TOLEDO-LUCAS COUNTY PLAN COMMISSIONS

DATE: November 2, 2018

REF: SUP-9004-18

SUBJECT: Request for an Amendment to Special Use Permit for a school at 4025 Indian Road

SITE PLAN

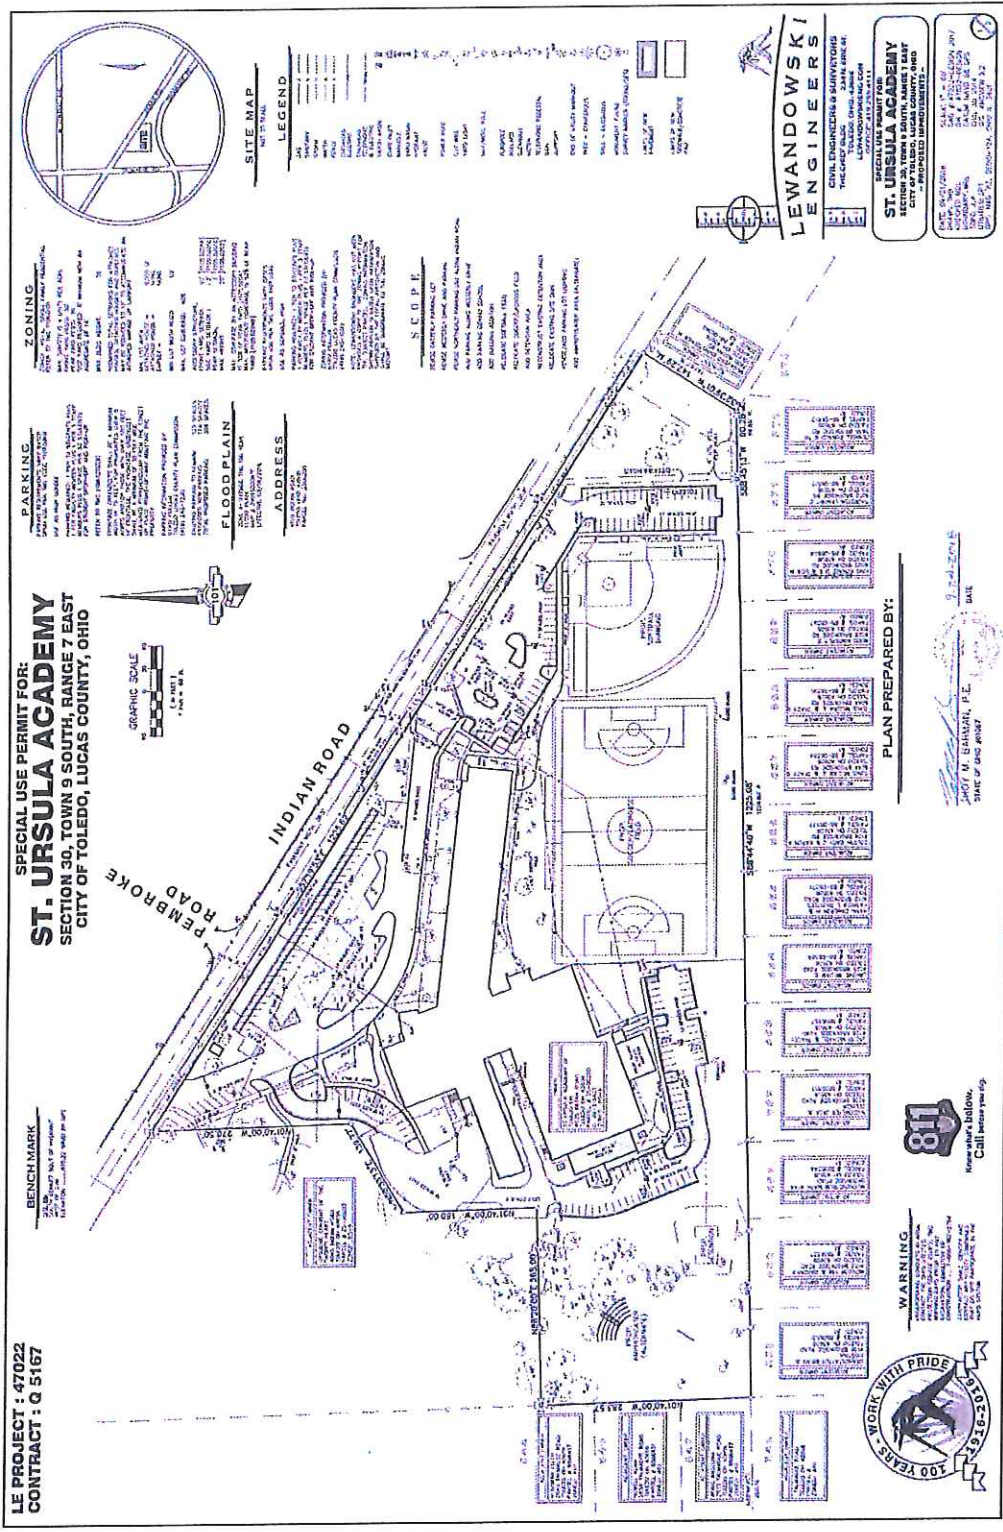
A large portion of the easterly parking lot will be removed and the parking area reconfigured to accommodate a proposed softball diamond. A proposed soccer/lacrosse field will be sited west of the softball diamond and south of the school building.

A new detention area is proposed in the southwest corner of the property.

The existing frontage greenbelt along the northerly parking lot along Indian Road is currently compliant with a thirty-foot (30’) width. However, the applicant wishes to reduce this greenbelt width to 17’8” in order to accommodate proposed revisions to the northerly parking lot. Staff is not supportive of this waiver because the site exceeds the minimum parking requirements by 171 spaces. The reduction of landscaping in this area to accommodate additional parking is not necessary.

The existing frontage greenbelt on the easterly parking lot is currently non-conforming with variable width of ±11.4’ to ±12.7’. The applicant wishes to reduce this greenbelt to 10’5” in order to accommodate the proposed modifications to the easterly parking lot. Staff supports this waiver request.

Approve a waiver of 12'4" of the required minimum width of 30' for the frontage greenbelt, to allow a 17'8" wide frontage greenbelt along the northerly parking lot.

Approve a waiver of 19'5" of the required minimum width of 30' for the frontage greenbelt, to allow a 10'5" wide frontage greenbelt along the easterly parking lot.

- a. A thirty (30') foot frontage greenbelt is required along the Indian Road right-of-way (TMC§1108.0202[B]3) **Applicant shall obtain a waiver to TMC§1108.0202(B)3, for 12'4" reduction along the northerly parking lot to allow for the proposed 17'8" frontage greenbelt; or submit a revised site plan indicating compliance with the required greenbelt. Applicant shall obtain a waiver to TMC§1108.0202(B)3, for 19'5" reduction along the easterly parking lot to allow for the proposed 10'5" frontage greenbelt; or submit a revised site plan indicating compliance with the required greenbelt. The greenbelt requires 41 trees (55 are proposed, which is acceptable). A continuous hedge is required to screen the parking lots; 117 evergreen shrubs are required.**

SHEET NO.
**OVERALL
 LANDSCAPE PLAN**

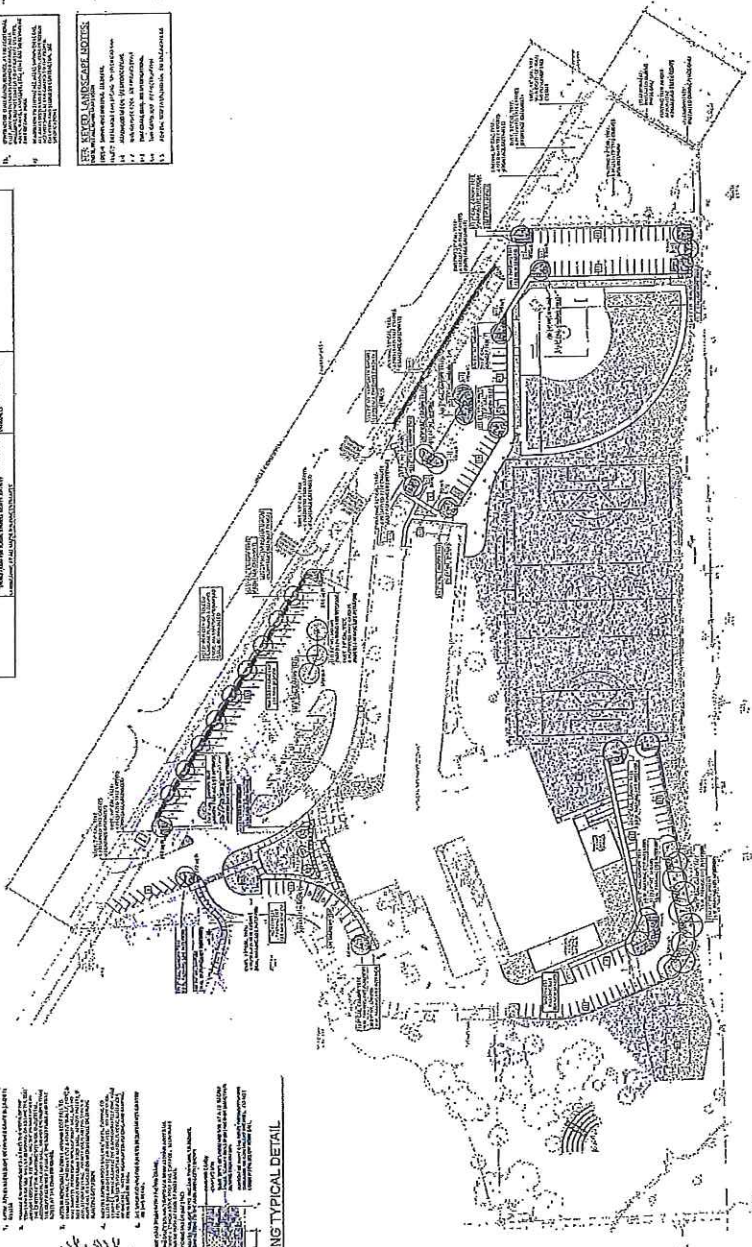
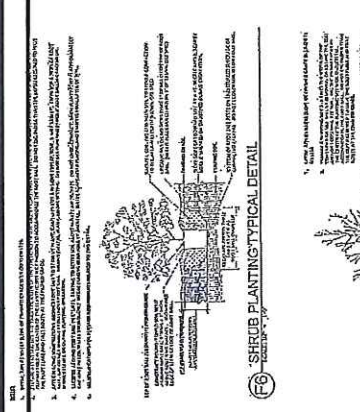
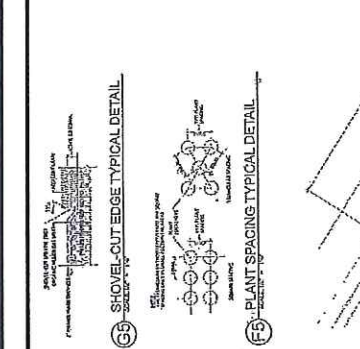
The frontage greenbelt also shall include at least one (1) tree for every thirty-foot (30’) of lot frontage. Based on this, the 1226’ of frontage requires 41 trees. The applicant is providing 55 trees (9 new and 46 existing). Additionally, the applicant shall provide 117 evergreen shrubs to meet the requirement for a continuous hedge to screen the parking lots. This is listed as a condition of approval.

The submitted landscape plan indicates that the applicant meets, or exceeds, all other landscape and screening requirements for parking lots and interior areas of the site. No landscape or screening is required on the south side of the property along the abutting residential uses (with the exception of the parking areas). Nevertheless, staff is requiring the placement of vegetative screening for the protection of the neighboring single-family properties from any adverse impact of the proposed athletic fields and this is listed as a condition of approval.

- b. Additional vegetative screening shall be added along the rear property line to protect neighboring single –family homes from any adverse impact of the proposed athletic fields. **This shall be depicted on a revised landscape plan – location and number of plantings shall meet the approval of the Plan Director.**
